Access Compliance Report

Public Rights-of-Way

(Pedestrian Signals)

Intersection ID: N/A	Main Street:	Cross Street: N/A	Location: N/A
ADA ID: CFA1EF843C37	Signal Type: One Push Button-Non APS	Overall Compliance: No	Severity Score: BTN 1: N/A BTN 2: N/A No BTN: N/A
Codes/Mitigation Info/Possible Solution		Field Measurements/Component Compliance

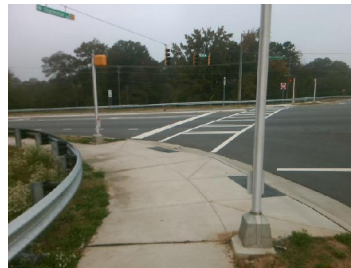
PROW/ADA: TMUTCD 4e.08, R404.2

Yes	B 1 Clear Xing Direction?	ClearlyMarked	N/A	B 2 Clear Xing Direction?	N/A
	B 1 Crossing Direction	To NE		B 2 Crossing Direction	N/A
No	B 1 DistanceTo XWalk (in)	66.0	N/A	B 2 DistanceTo XWalk (in)	N/A
Yes	B 1 DistanceTo Curb (in)	61.0	N/A	B 2 DistanceTo Curb (in)	N/A
Yes	B 1 Diameter (in)	2.0	N/A	B 2 Diameter (in)	N/A

Possible Solutions: Replace Signal Push Button With APS Button on New Post. Remove & Relocate Sign.
